# SERVICE BULLETIN

**BULLETIN:** MON 97-005

**MODEL:** CMH7379L

**SUBJECT:** Q407 Failure Causing No Raster or Small Horizontal Size

**Figure 1**

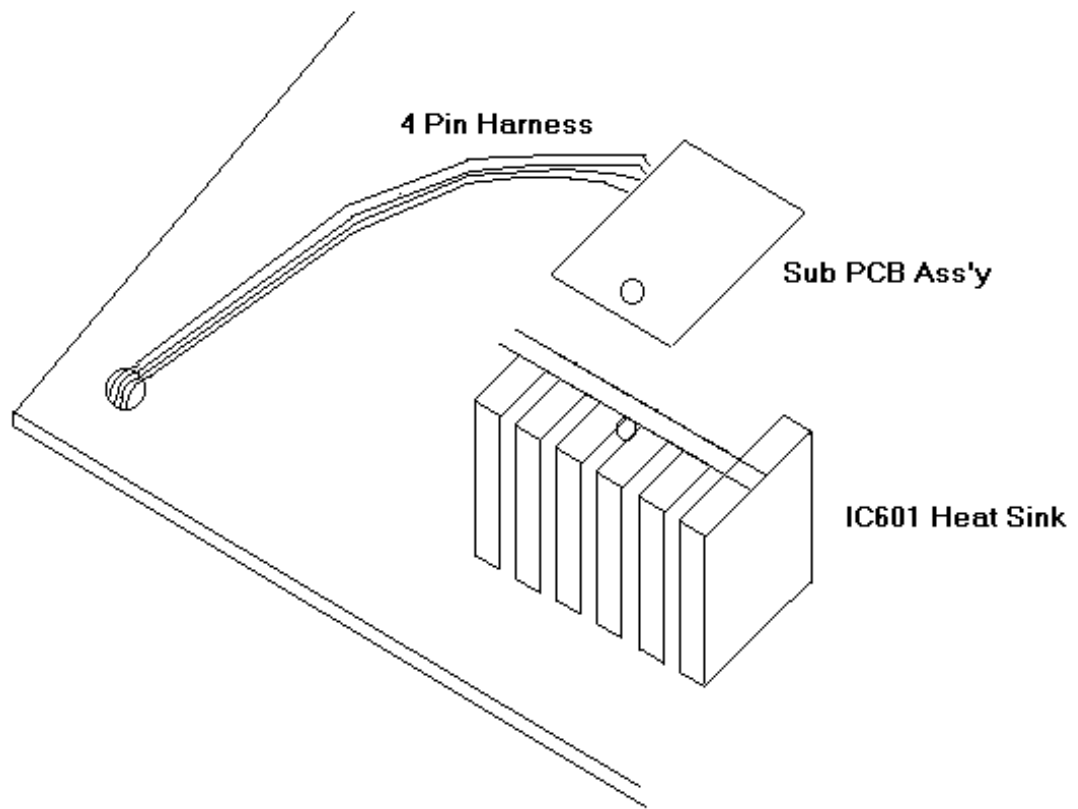
**BACKGROUND:** Q407 fails due to a transient pulse and current when mode switching from DOS to Windows. This occurs with a Matrox video card installed in the computer.

**SOLUTION:** Add a sub-PCB assembly as in figures 1 and 2 and a snubbing circuit for the horizontal output as in figure 3.
